### Inland Transport Committee

#### Working Party on Lighting and Light-Signalling

**Regulations Nos. 37 (Filament lamps), 99 (Gas discharge light sources), 128 (Light emitting diodes light sources) and the Consolidated Resolution on the common specification of light source categories**

### **Proposal for amendments to the original version of the Consolidated Resolution on the common specification of light source categories**

Sheet L1/1

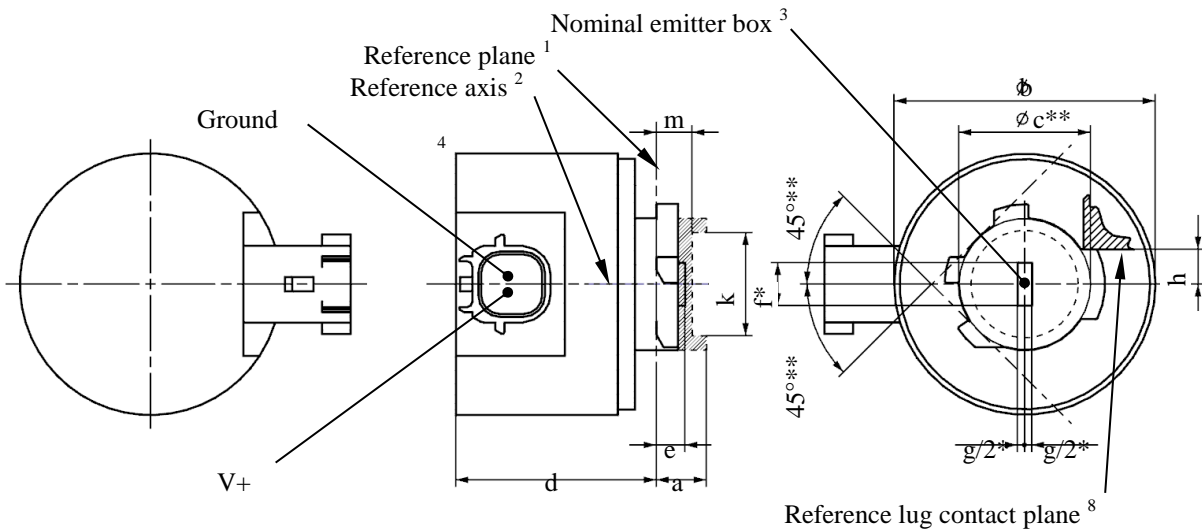
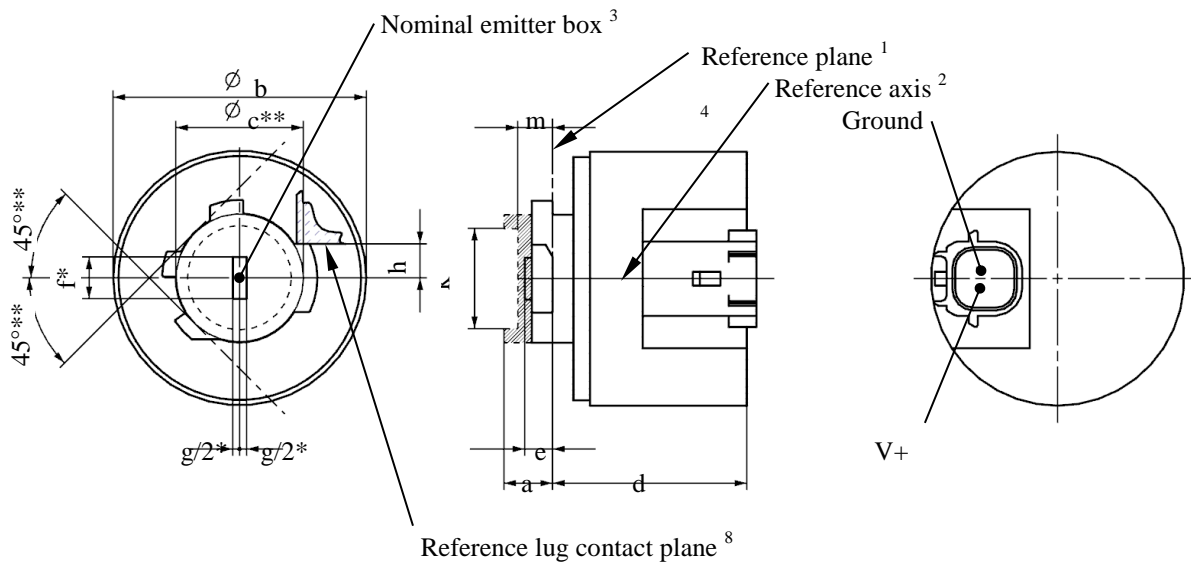
*Before sheet LR1/1, insert new sheets L1/1 to 5, to read (see the following pages; one page per sheet):*

\* Dimensions f and g see table 2

\*\* Reference system for the emitter box: for detailed dimensions see relevant cap data sheet.

\*\*\* For the notes see sheet L1/2.

Figure 3

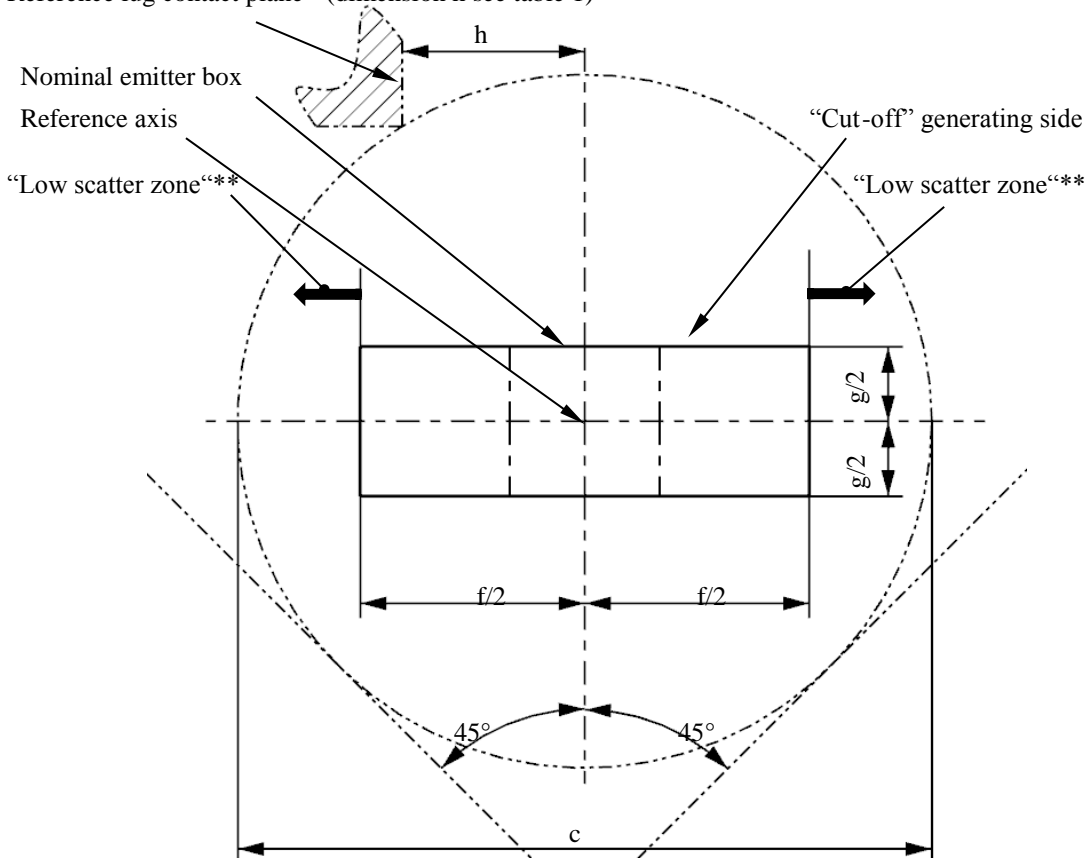
The position, the contrast and the uniformity of the light emitting area are checked by the nominal emitter box system defined in figure 3, which shows the projection when viewing along direction of the reference axis ( $\text{Gamma} = 0^\circ$ ) as defined in Figure 4.

**Definition of the nominal emitter box with dimensions as specified in table 2**

Reference lug contact plane<sup>9</sup> (dimension h see table 1)

Figure 4  
**Set-up to measure the luminous intensity distribution for L1A**

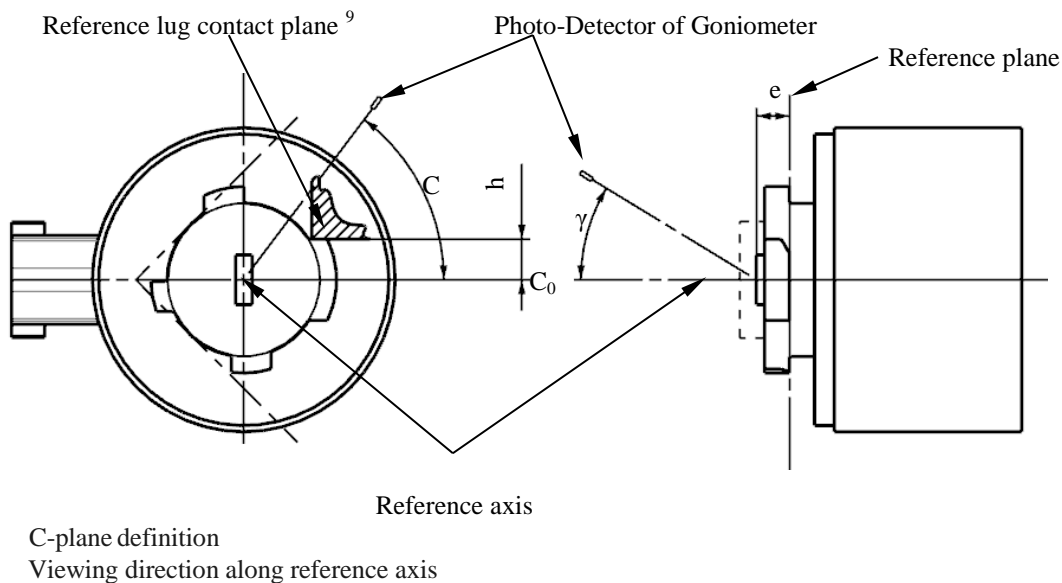
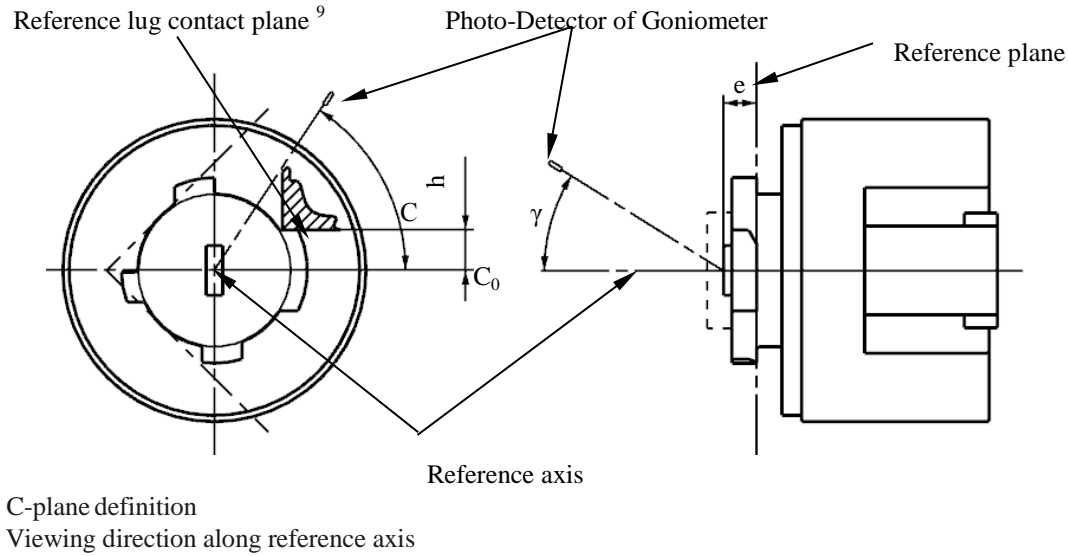
The light source is mounted on a flat plate with the corresponding mounting lug features. The plate is mounted to the goniometer table by a bracket, so that the reference axis of the light set-up is described in Figure 4.

Figure 5  
Set-up to measure the luminous intensity distribution for L1B
